ADA Curb Ramp New Construction Inspection Form (Perpendicular)

Nw 287 ave

24952.54

Nw Shaddon st

PERPENDICULAR RAMP (PR)

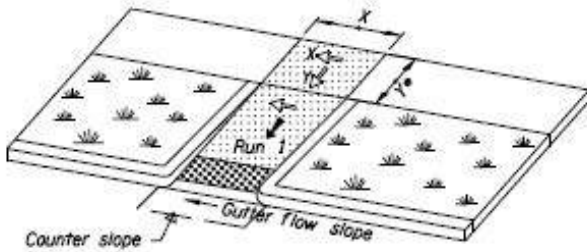
5.4

RR1 ICRR jbox in turn space
